SUNDRY NOTICES AND REPORTS ON WELLS Do not use this form for proposals to drill or to re-enter an abandoned well. Use form 3160-3 (APD) for such proposals.

8. Well Name and No. WILDER 29 FEDERAL AC 5H

9. API Well No. 30-025-41509-00-X1

WILDER FEDERAL AC 29 5H
BACKFILL AROUND PIPE

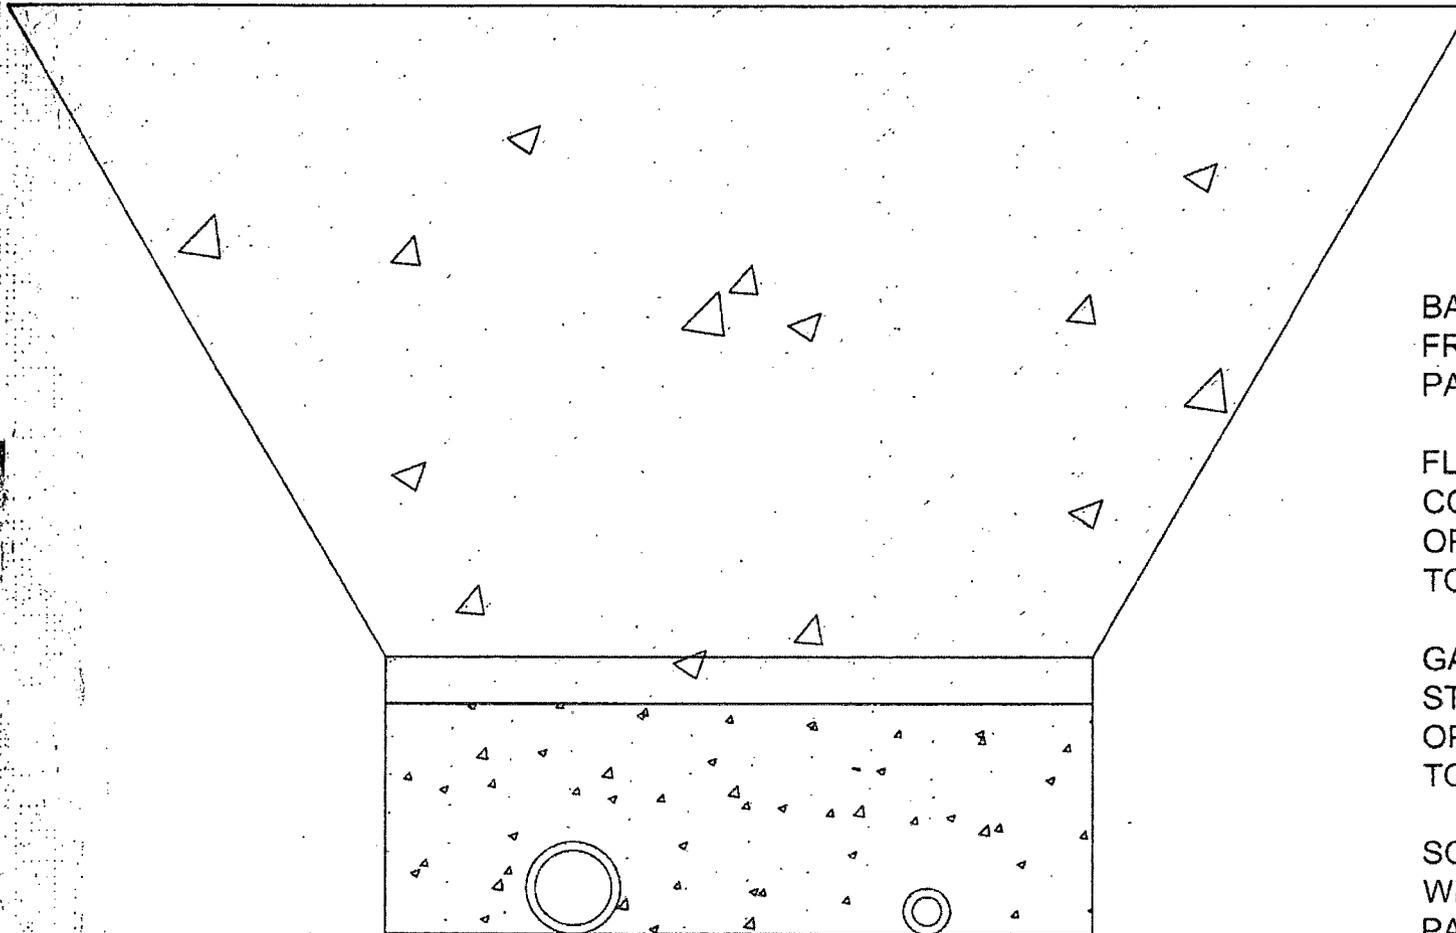
ConocoPhillips Company respectfully requests to amend the method of installation as it pertains to the products line from surface to buried. The route for the pipeline has not changed. The line will be 4" Steel, operated at up to 1480# psi from the well to the Wilder 29 Central Tank Battery. All activity will be kept in the utility corridor already authorized under the APD.

In addition, per conversation with Cody Layton on 02/18/2014, ConocoPhillips Company respectfully requests to amend the Conditions of Approval for the authorized ROW width of 15' in the APD. A larger ROW width is needed for ConocoPhillips Company to comply with our internal safety practices governing separation between buried lines and roadways. We request the ROW width be amended to 30' permanent with 20' construction workspace.

BACKFILL DIRT TO BE AS
FREE OF ROCKS AND LARGE
PARTICLES AS POSSIBLE

FLOW LINE WILL BE 4"
COATED STEEL PIPE w/ AN
OPERATING PRESSURE UP
TO 1480# PSI.

SOFT FILL DIRT OR SAND
WITH NO ROCKS OR SOLID
PARTICLES GREATER THAN
1" IN CIRCUMFERENCE
